Architect's Supplemental Instructions

Architect's ASI No: 050

Project:
Webster University
Interdisciplinary Science
Building

Date Issued: 02/16/2017

**LEVEL 02 AREA B FLOOR
PLAN - MECHANICAL**

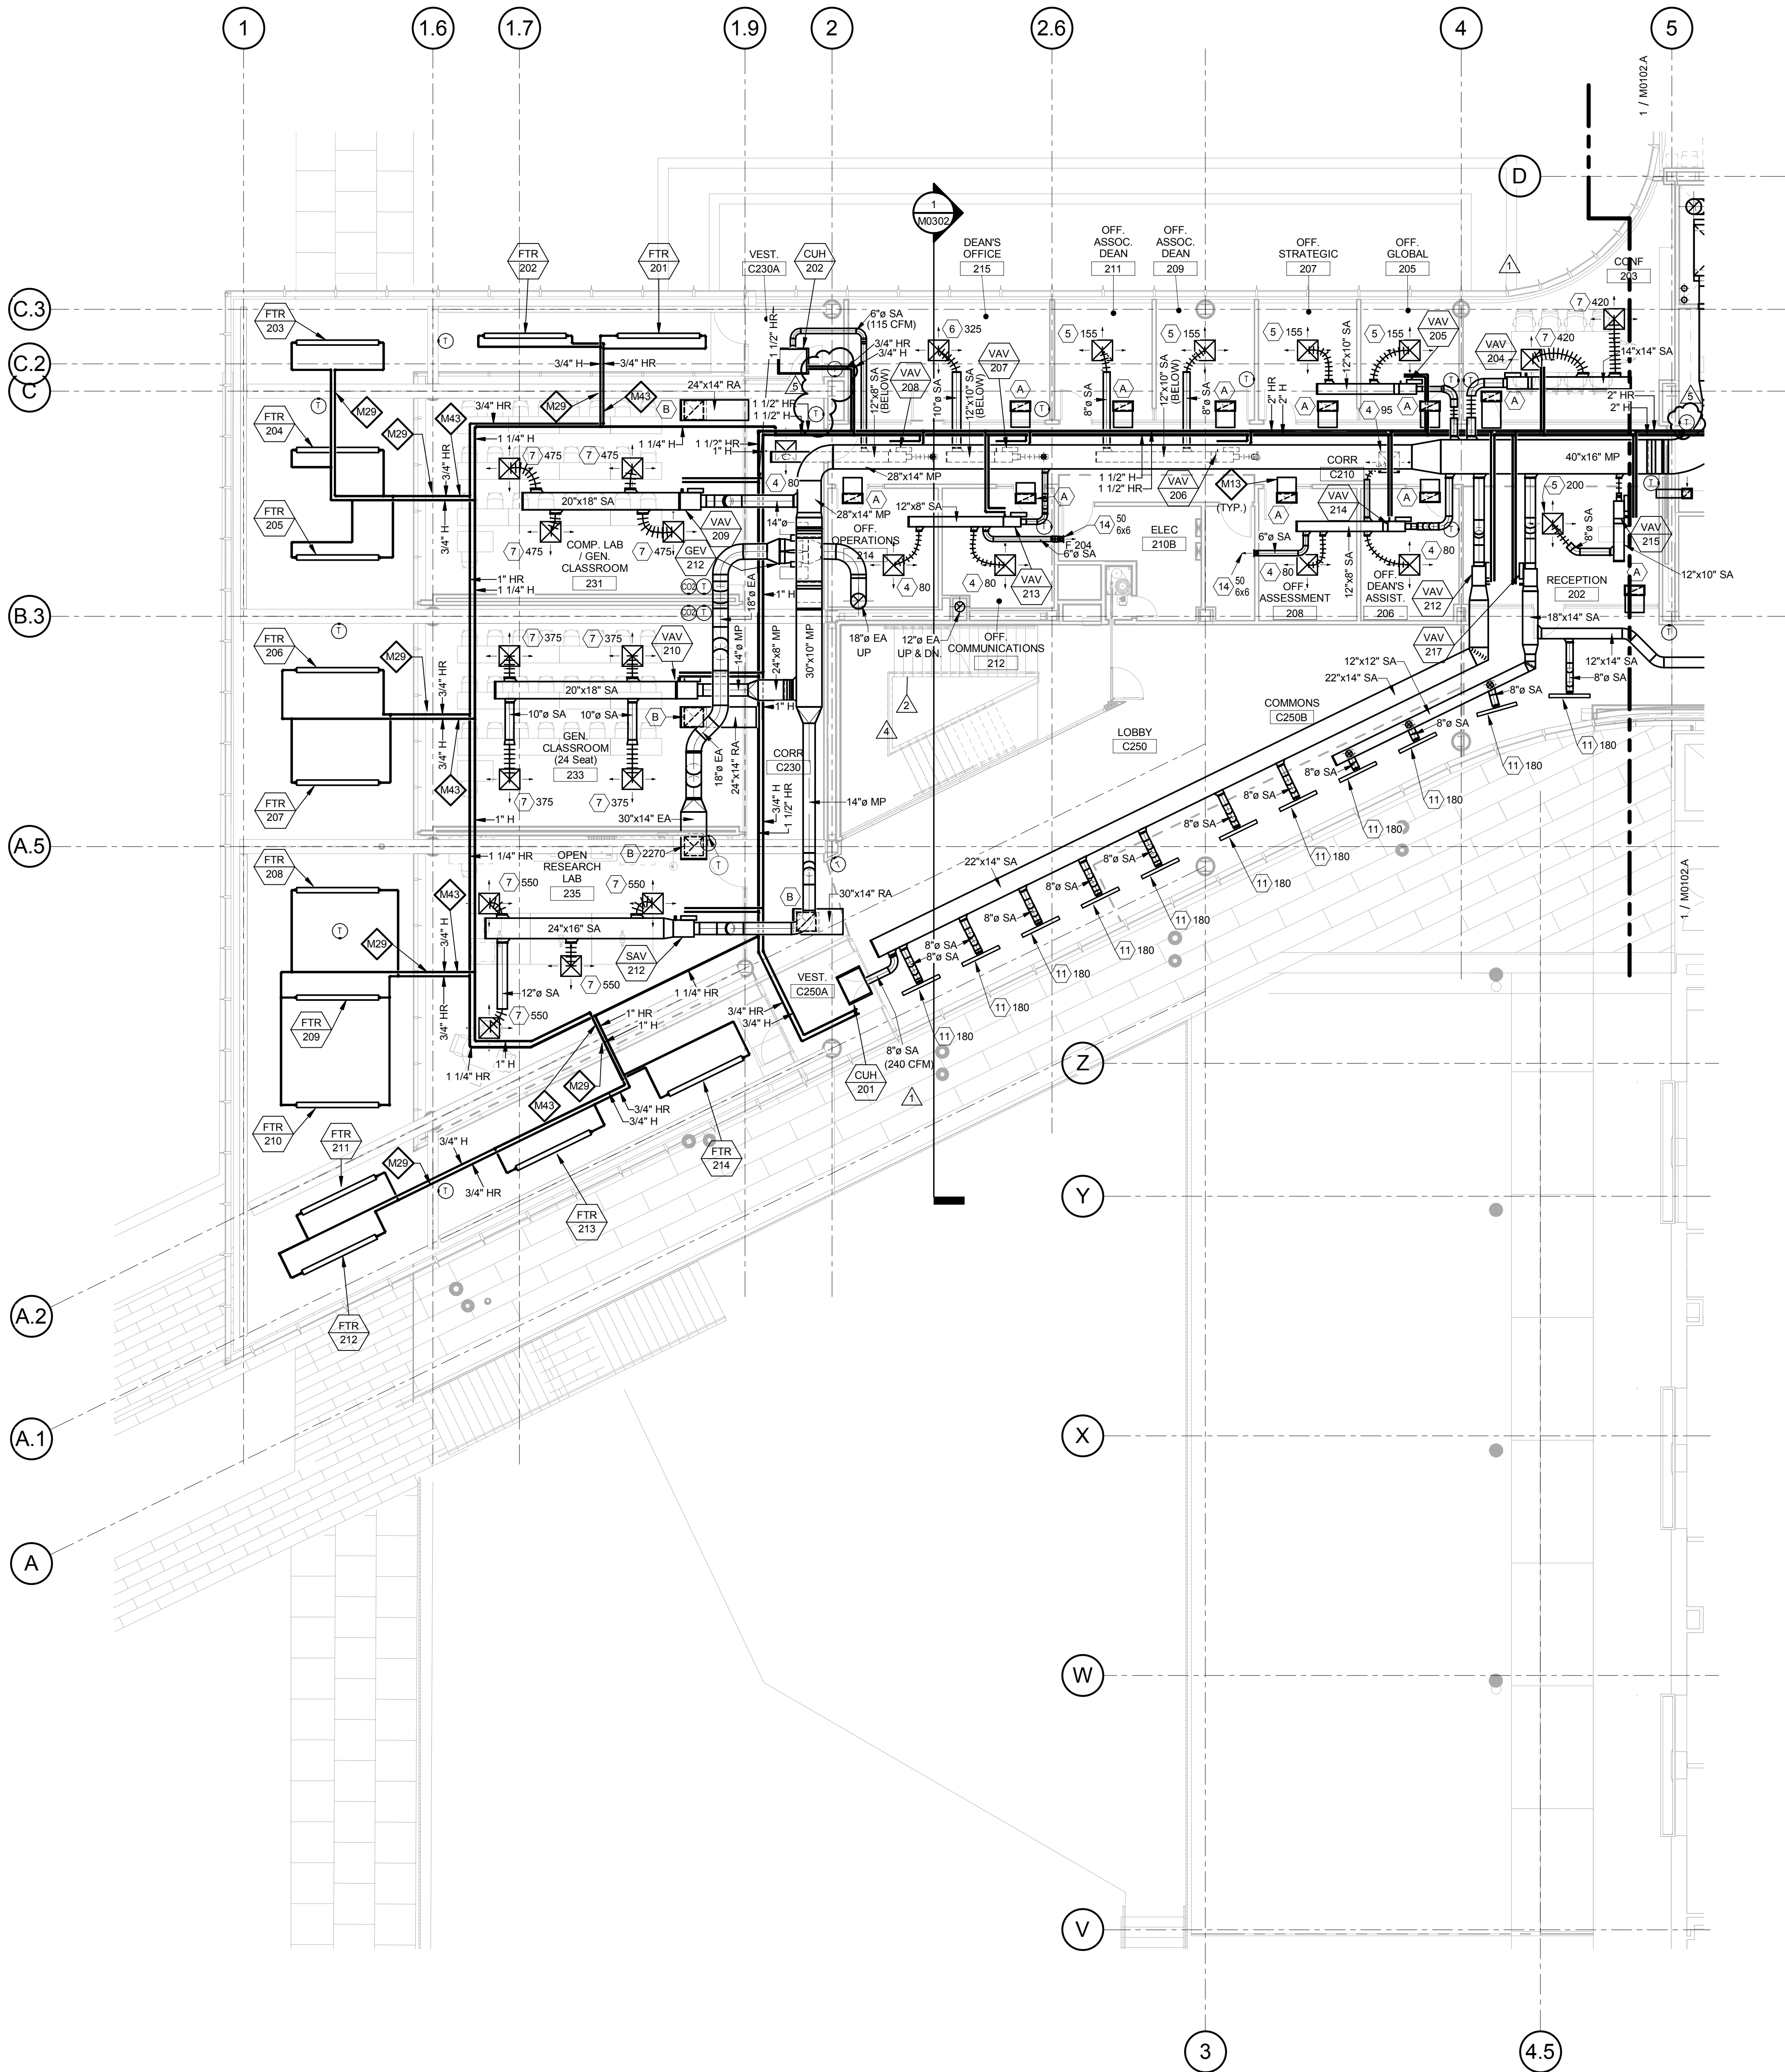
SHEET M0102.B

- Modify thermostat locations.
